Intersection ID: 29377	Main Street: BUCKVALLEY_DR	Cross Street: EULER_WY	Location:	NW
ADA ID: 5F6AA6D5621A	Ramp Type: PerpDiag	Initial Pass/Fail: Fail	Overall Compliance: No	Severity Score: 8.75

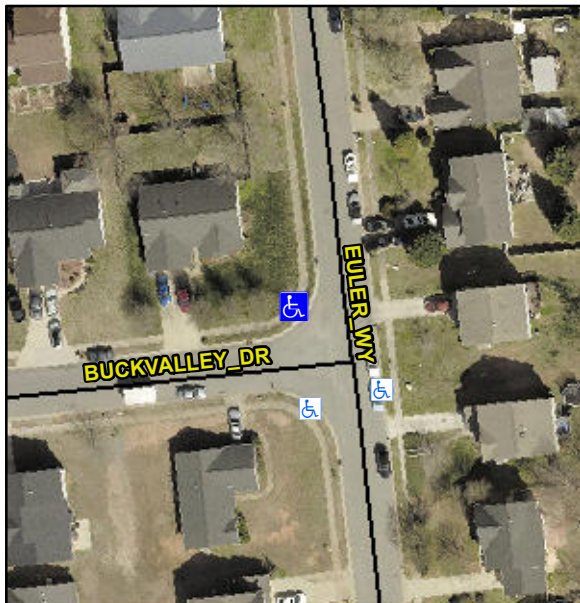
Codes/Mitigation Info/Possible Solution				Field Measurements/Component Compliance					
	Possible Solutions:			Remove & Replace Curb Ramp With Two New Directional Ramps or Equivalent.					
	Surveyor Notes:			N/A					
	PROW/ADA:			R304.5.1					
	Street 1 Name			BUCKVALLEY DR					
	Stop Condition-Street 2			StopSign					
	Street 2 Name			EULER WY					
	Stop Condition-Street 1			None					
	Total Cost:			\$ 3200.00					
Compliance		Description		Data	Compliance		Description		Data
N/A	Ramp Length (in)			94.5	Yes	Ramp Slope (%)			5.1
No	Ramp Width (in)			47.0	Yes	Ramp XSlope (%)			0.1
N/A	Flare Type LT			N/A	N/A	Flare Type RT			N/A
N/A	Flare Slope LT (%)			N/A	N/A	Flare Slope RT (%)			N/A
N/A	Flare Traversable LT?			N/A	N/A	Flare Traversable RT?			N/A
N/A	Landing Length (in)			N/A	N/A	DWS Provided?			N/A
N/A	Landing Width (in)			N/A	N/A	DWS Contrast?			N/A
N/A	Landing Slope (%)			N/A	N/A	DWS Length (in)			N/A
N/A	Landing X Slope (%)			N/A	N/A	DWS Full Width?			N/A
